# United States Patent and Trademark Office

APPLICATION NO.	FILING DATE	FIRST NAMED INVENTOR	ATTORNEY DOCKET NO.	CONFIRMATION NO.
10/518,123	06/20/2005	Anthony X. Earle	84322	3282
1333 DATENT I EC	7590 05/16/2007		EXAMINER	
PATENT LEGAL STAFF EASTMAN KODAK COMPANY			FENWICK, WARREN K	
343 STATE STREET ROCHESTER, NY 14650-2201			ART UNIT	PAPER NUMBER
ROCHESTER	, 111 11030 2201		2809	
	•		MAIL DATE	DELIVERY MODE
	•		05/16/2007	PAPER

Application No.	Applicant(s)				
Office Action Commons	10/518,123	EARLE ET AL.				
Office Action Summary	Examiner	Art Unit				
	Warren K. Fenwick	2809				
The MAILING DATE of this communication app Period for Reply	ears on the cover sheet with the c	orrespondence address				
A SHORTENED STATUTORY PERIOD FOR REPLY IS SET TO EXPIRE 3 MONTH(S) OR THIRTY (30) DAYS, WHICHEVER IS LONGER, FROM THE MAILING DATE OF THIS COMMUNICATION.  - Extensions of time may be available under the provisions of 37 CFR 1.136(a). In no event, however, may a reply be timely filed after SIX (6) MONTHS from the mailing date of this communication.  - If NO period for reply is specified above, the maximum statutory period will apply and will expire SIX (6) MONTHS from the mailing dat

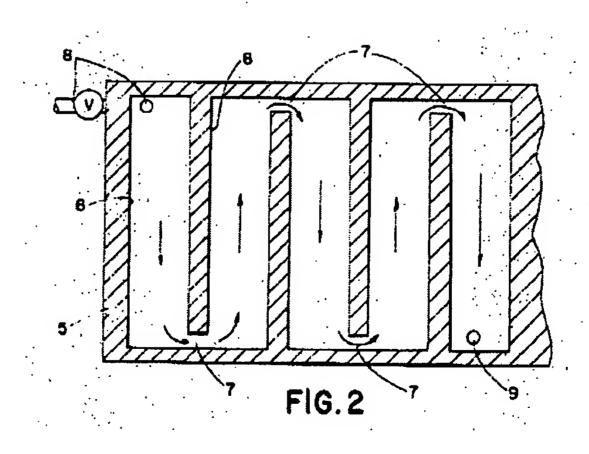
- 9. Claims 1-2, 5, 7-9, and 12-13, 16-18 are rejected under 35 U.S.C. 102(b) as being anticipated by Smith et al. (U. S. Patent # 3,575,101).
- 10. Regarding **claim 1**, Smith et al. disclose a photographic processing **a**pparatus (Figure 1) for processing photographic material (Figure 1, element 12) comprising a base member (Figure 1, element 5) for locating the material to be processed, the base member being provided with a channel (Figures 1-2, element 6) at either side thereof for holding the processing solution, and spreading means (Figure 1, element 2 and Figure 2, element 7) for transferring the solution from one side channel to the other, thereby spreading the solution across the material.

- 11. Regarding **claim 2**, Smith et al. disclose a photographic processing **a**pparatus, wherein the side channels (Figure 1, element 6) are shallow (column 2, lines 49-51).

- 12. Regarding **claim 3**, Smith et al. disclose a photographic processing **a**pparatus, wherein the depth of the channels (Figure 1, element 6) is between 1 mm and 50 mm.

- 13. Regarding **claim 5**, Smith et al. disclose a photographic processing **a**pparatus, wherein the channels are curved (Figure 1, element 6).
- 14. Regarding **claims 7-9**, Smith et al. disclose a photographic processing apparatus, wherein a roller (Figure 1, elements 2-4), pad, or air spreads the solution across the material.

- 15. Regarding **claim 12**, Smith et al. disclose a method of processing photographic material (Figure 6, element 15) comprising the steps of locating the material on the base member (Figure 1, element 5), supplying solution to at least one of the side channels (Figure 1, element 6) and transferring the solution from one channel to the other across the material, thereby causing the solution to be spread (Figure 1, elements 2-4) and agitated uniformly over the material.

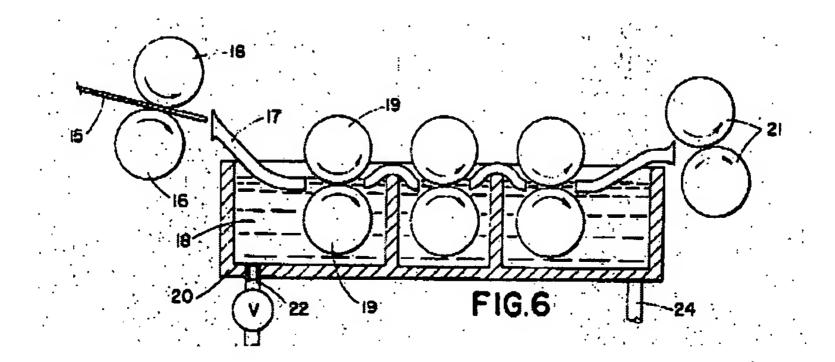
16. Regarding **claim 13**, Smith et al. discloses a method of processing photographic material (Figure 6, element 15), wherein the processing solution (Figure 6, element 18) is metered into the channels (Figure 6, valve "V").

17. Regarding **claims 16-18**, Smith et al. discloses a method of processing photographic material, wherein the solution is spread across the material by means of a roller (Figure 1, elements 2-4), pad, or air knife.
